**Substantive response of the Local Highway
Authority to a planning consultation received
under The Development Management Order.**

Planning Application Number: 23/00573/FUL

Application Address: Land To The West Of Normandy Way Hinckley Leicestershire

Full planning application for 153 dwellings with a vehicular access from the factory access road and existing roundabout on the A47, drainage, landscaping, public open space, ground remodelling and supporting infrastructure and utilities.

Figure 1: Proposed Site Access reproduced from Capricorn Transport Planning Consultants drawing number: C21021/DR001, dated 14 November 2022.

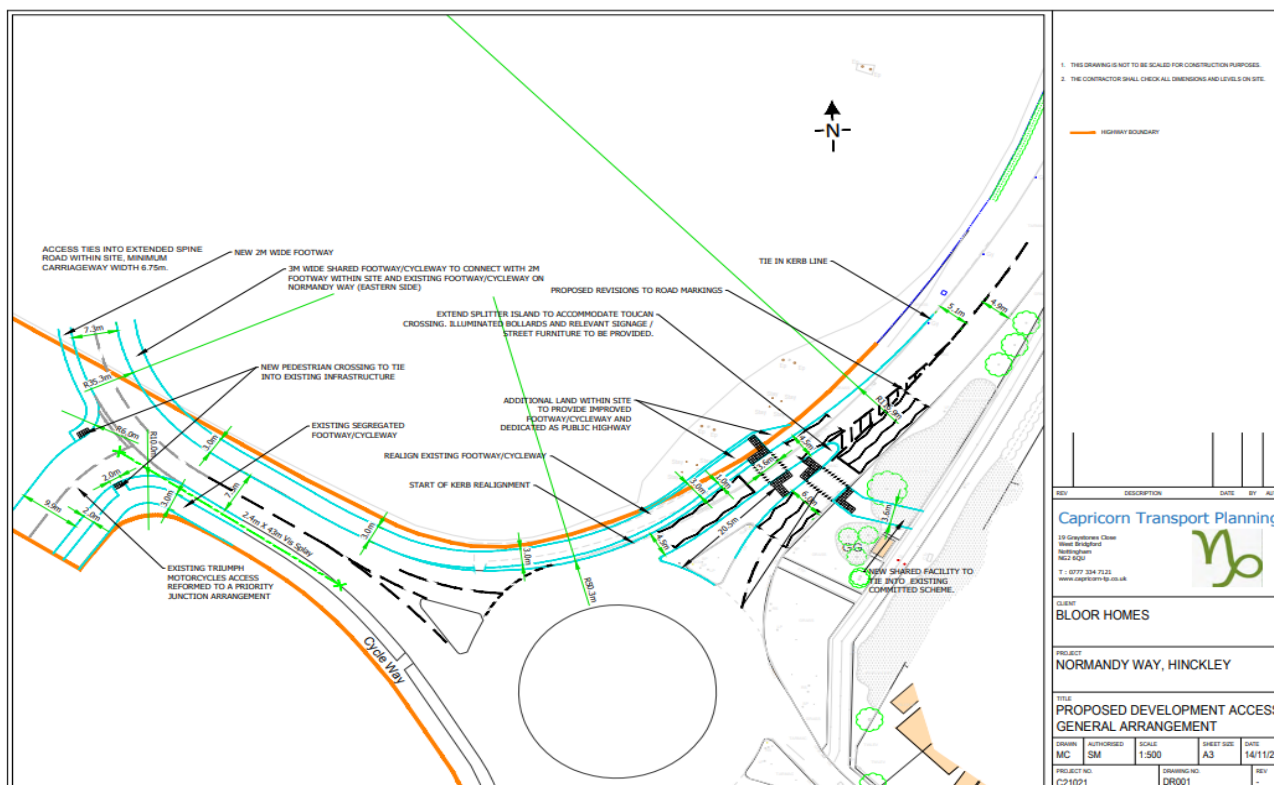
The applicant has not included a Stage 1 Road Safety Audit (RSA1) as part of the application. Whilst the applicant has concluded in Paragraph 9.2.2, that satisfactorily vehicular access to the development can be achieved and the proposals would be subject to a RSA1, Part 3 of the LHDG requires a RSA1 to be submitted as part of the planning application.

Therefore the applicant should submit a RSA1, Designers Response to any problems raised in the audit and amended drawing (if required) for review by the LHA.

Figure 2: Proposed Site Access reproduced from Capricorn Transport Planning Consultants drawing number: C21021/DR001, dated 14 November 2022.

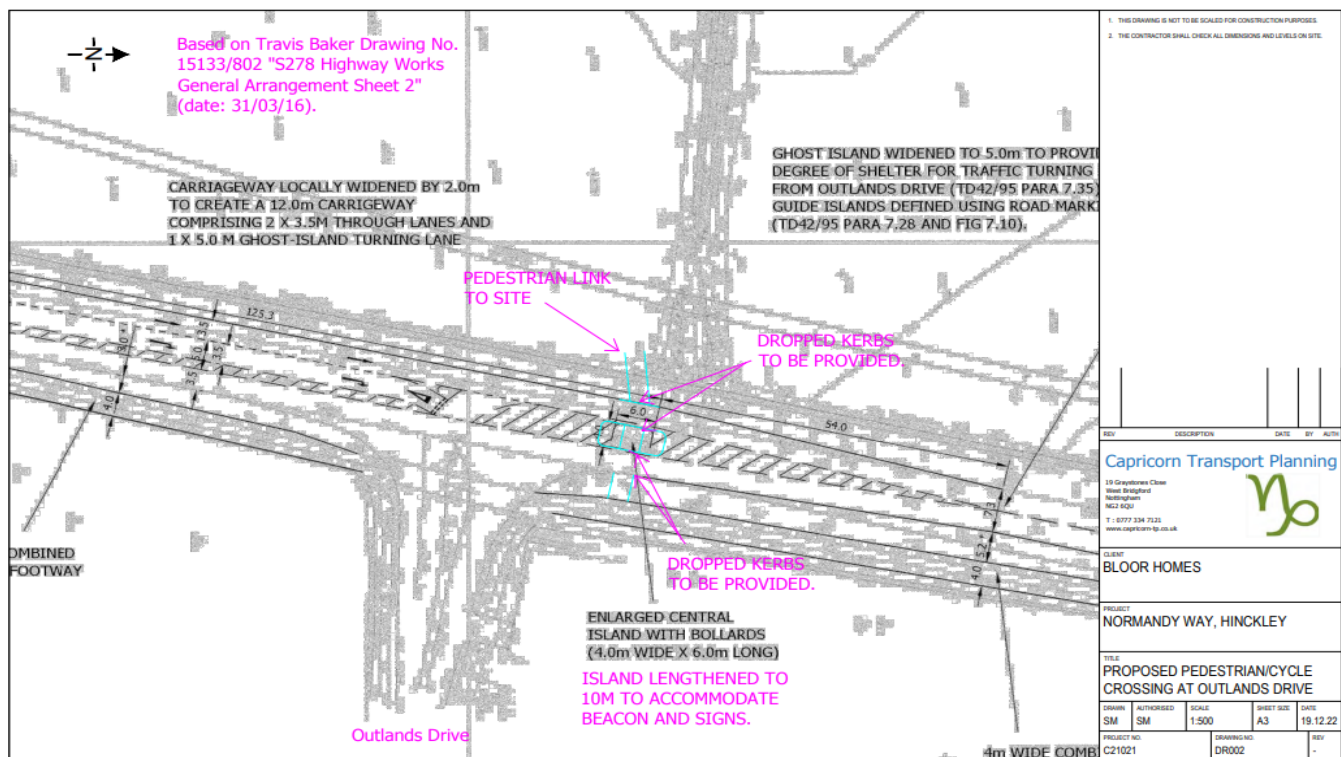
Once again the applicant has not provided a RSA1 for the highway works which should be submitted for the planning application.
